KAYLEES COVE SUBDIVISION

Engineering Comments: FINAL PLAT COMMENTS (should be addressed prior to submitting the FINAL PLAT for review and/or signature by the City Engineer):

APPLICATION NUMBER 4 DATE October 20, 2022

DETAIL SITE PLAN

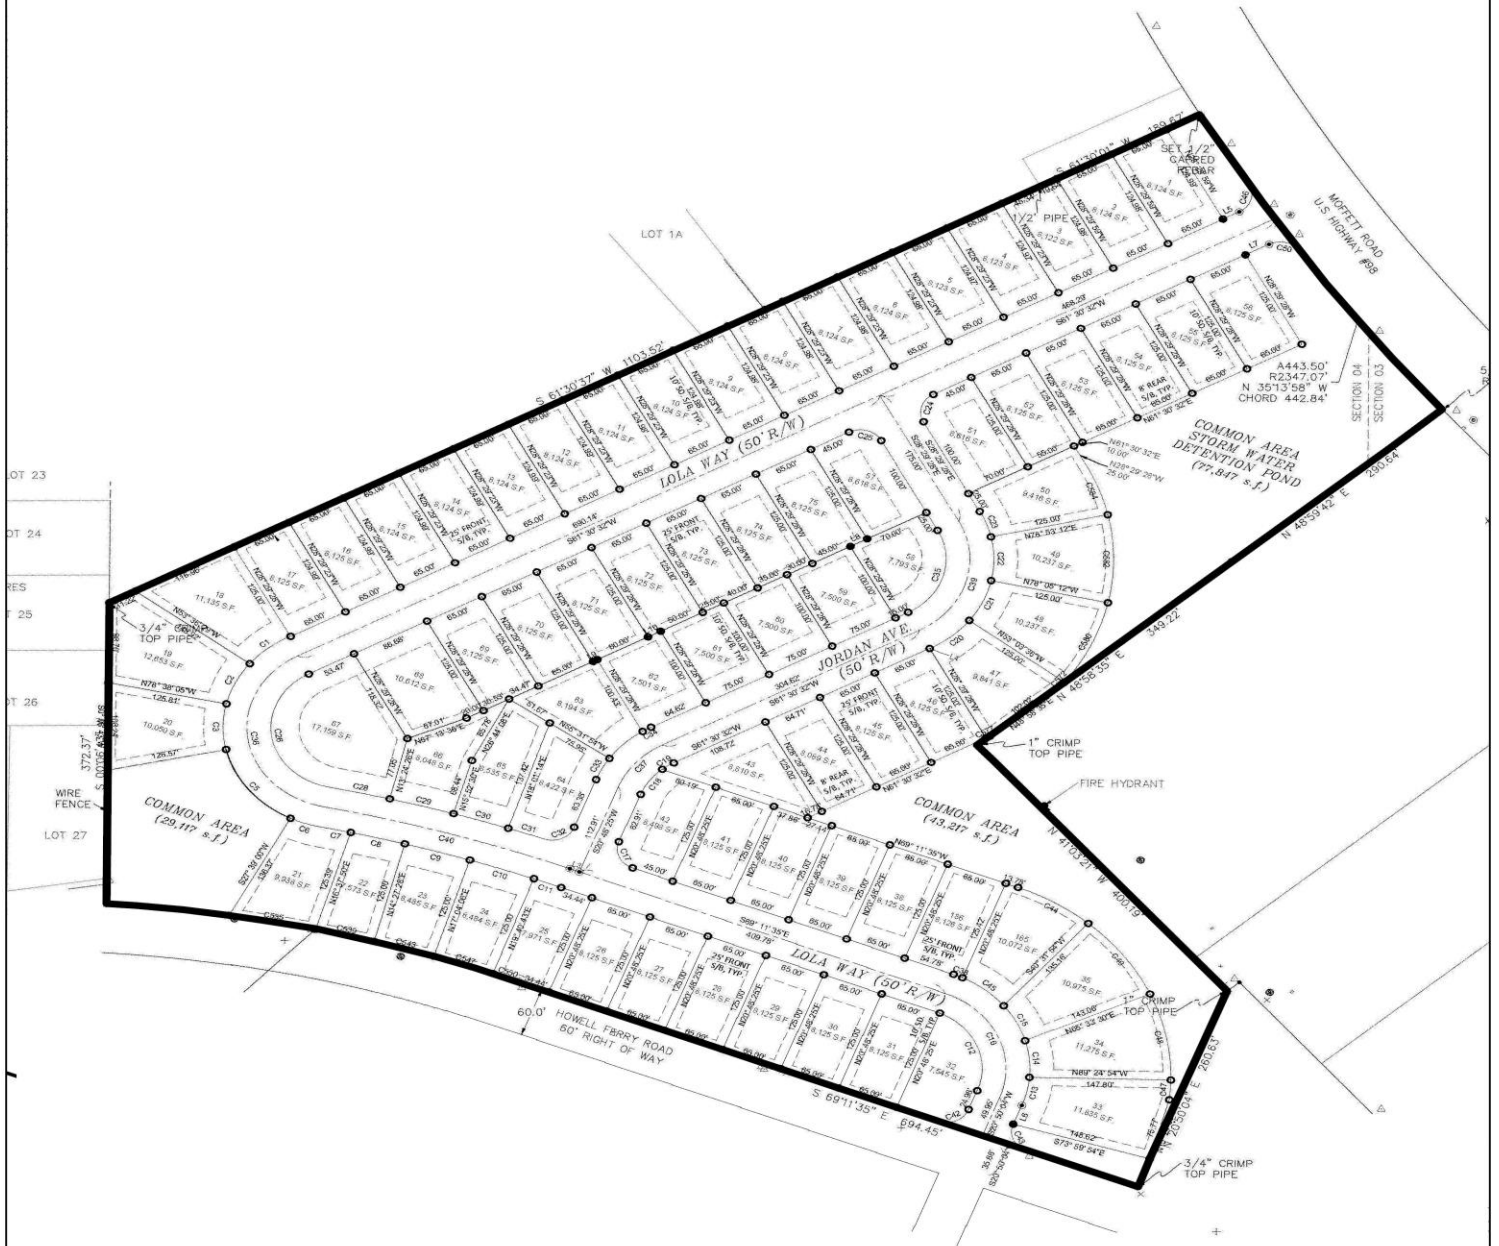
- A. Provide all of the required information on the SUBDIVISION PLAT (i.e. signature blocks, signatures, certification statements, written legal description, required notes, legend, scale, bearings and distances) that is required by the current Alabama State Board of Licensure for Professional Engineers and Land Surveyors.

- B. Provide reference, on the map and the description, to a monumented corner.
- C. Provide and label the monument set or found at each subdivision corner.

- D. Provide a Vicinity Map.
- E. Provide a North Arrow on Sheet 1 of 2.
- F. Provide a legend.
- G. Provide curve data for ALL of the labeled curves.
- H. Mark each proposed ROW as PUBLIC or PRIVATE.

- I. Is the USPS requiring a mail kiosk? Show and label the proposed kiosk on private property.
- J. Street names are subject to approval through the Engineering Dept.

- K. Give a unique label to each of the separate Common Areas (i.e. No. 1, No. 2).
- L. Label the adjoining property Owners.
- M. Revise NOTE #9 (unnumbered) to read – “All existing and proposed detention facilities, common areas, and wetlands shall be the responsibility of the Property Owner(s), and not the responsibility of the City of Mobile.”

- N. Provide a written legal description and matching bearing and distance labels for the proposed subdivision boundary.
- O. Revise the plat to label each lot with its size in acres also, or the furnishing of a table on the Plat providing the same information.

- P. Revise the signature block from “MOBILE CITY ENGINEERING” to “CITY ENGINEER”.
- Q. Provide the Surveyor’s Certificate.
- R. The proposed streets are considered PRIVATE until the roadways and dedicated ROW are accepted by the City.

The site has frontage on Moffett Road and Howells Ferry Road. Moffett Road is a component of the Major Street Plan with a planned 100-foot right-of-way. The preliminary plat does not label Moffett Road with its current right-of-way width. Therefore, the plat should be revised to label Moffett Road with its current right-of-way width, and if less than 50-feet from the centerline along the site frontage, dedication should be required to provide 50 feet from the centerline of Moffett Road. Howells Ferry Road is a minor street with a 50-foot right-of-way, and without curb and gutter, requiring a 60-foot right-of-way. Therefore; dedication should be required to provide 30-feet from the centerline of Howells Ferry Road.

The preliminary plat indicates that access to the subdivision will be via both Moffett Road and Howells Ferry Road. Proposed new streets are labeled to have compliant 50-foot rights-of-way, and these labels should be retained on the Final Plat, if approved. All corner lots are indicated to have compliant 25-foot or more corner radius curves. Lots are labeled with their sizes in square feet only. The plat should be revised to label each lot with its size in both square feet and acres, after any required frontage dedication, or a table should be furnished on the Final Plat providing the same information.

All lots, are indicated to have a compliant and standard 25-foot minimum building setback from the street frontages, except for Lots 21 through 32 along Howells Ferry Road. The plat should be revised to indicate a 25-foot minimum building setback line along Howells Ferry Road for these lots as measured from any required frontage dedication. No setback lines are indicated for Lot 32. Therefore, the plat should be revised to indicate the 25-foot minimum building setbacks along all street frontages for Lot 32; however, it should be noted that the dimensions of this lot may need to be adjusted to provide adequate buildable area outside of the required setbacks. A "Typical Lot Building Setback Layout" provided on the plat implies that all lots would have the same utilities easement and setback configuration. However, most corner lots differ from these setbacks. This layout should be revised to indicate which lots would be subject to this standard layout and which lots would differ. As easements are indicated, the note on the preliminary plat stating that no structures may be placed or constructed within any easement without the permission of the easement holder should be retained on the Final Plat, if approved. The Typical Lot Building Setback Layout should be revised to also illustrate compliant rear and side yard setbacks.

The preliminary plat labels three (3) areas as Common Areas, with their sizes in square feet provided. The size labels should be revised to also include the area in both square feet and acres, after any required frontage dedication, for each Common Area. There is a note on the preliminary plat stating that all proposed detention facilities, Common Areas and wetlands shall be the responsibility of the property owner(s) and not the responsibility of the City of Mobile. This note should be revised on the Final Plat to simply state that the maintenance of all Common Areas is the responsibility of the property owners. There are two (2) areas on the preliminary plat not identified as either lots or Common Areas. One is in the Northwest corner of the site along Moffett Road, and the other is in the Southeast corner of the site along Howells Ferry Road. As each is too small to be a lot, the plat should be revised to also label these areas as

The subdivision is proposed to have numerous drainage and utility easements. The note on the preliminary plat stating that no structures shall be constructed or placed within any easement without permission of the easement holder should be retained on the Final Plat.

It should be noted that the United States Postal Service (USPS) has established National Delivery Planning Standards requiring centralized mail delivery receptacles for new single-family residential developments. This would require an area within a new subdivision to be developed with mailbox kiosks as opposed to individual mailboxes at each lot. The applicant should coordinate with the USPS and revise the plat to provide a mailbox kiosk on private property that conforms with the required setbacks.

- 1) revision of the plat to label Moffett Road with its current right-of-way width, and if less than 50 feet from the centerline, dedication is required to provide 50-feet from the centerline;

- 2) dedication to provide 30-feet from the centerline of Howells Ferry Road;
- 3) retention of the right-of-way width labels of the proposed streets on the Final Plat;

- 4) revision of the plat to label each lot and Common Area with its size in both square feet and acres, after any required frontage dedication, or the furnishing of a table on the Final Plat providing the same information;

- 5) revision of the plat to indicate the 25-foot minimum building setback line along Howells Ferry Road for Lots 21 through 32, as measured from any required frontage dedication;

- 6) revision of the plat to indicate the 25-foot minimum building setback line along the internal street for Lot 32;
- 7) revision of the Typical Lot Building Setback Layout to indicate which lots would be subject to this standard layout and which lots would differ, and to include compliant front, side and rear yard setbacks;

- 8) retention of the note on the preliminary plat stating that no structures may be placed or constructed within any easement without the permission of the easement holder on the Final Plat;

- 9) revision of the note concerning the maintenance of the Common Areas to simply state on the Final Plat that the maintenance of all Common Areas is the responsibility of the property owners;

- 10) revision of the plat to label the area in the Northwest corner of the site along Moffett Road, and the area in the Southeast corner of the site along Howells Ferry Road, as Common Areas, with their sizes provided in both square feet and acres on the Final Plat;

- 12) revision of the plat, if necessary, to conform to United States Postal Service National Delivery Planning Standards, and if a mailbox kiosk is provided, the placement thereof must be on private property and comply with the setback requirements of the Zoning Ordinance;
